November 29, 2007

Subject: Non-Compliance Complaint & Public Records Act Request – Palomar Energy Center
(Docket No. 01-AFC-24C)

Figure 4 (June 2007)

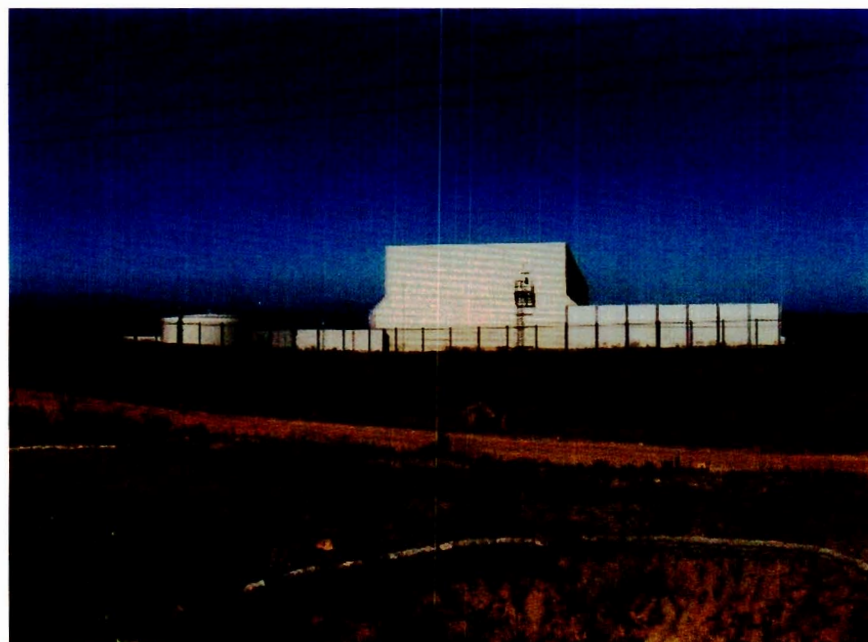
Figures 2 – 6 also represent that the project based on the CEC own staff analysis Conditions of Certification that unless all mitigation measures are implemented the project would reflect that the visual impacts are adverse because those mitigation measures have not been implemented.

Under Section 1237(a)(5) of Title 20, the owner of the PEC at the minimum should be required to implement approved landscape plans for all the designated KOPs to screen their facility utilizing their own easement property shown in Figures 3 – 5 next to their facility.
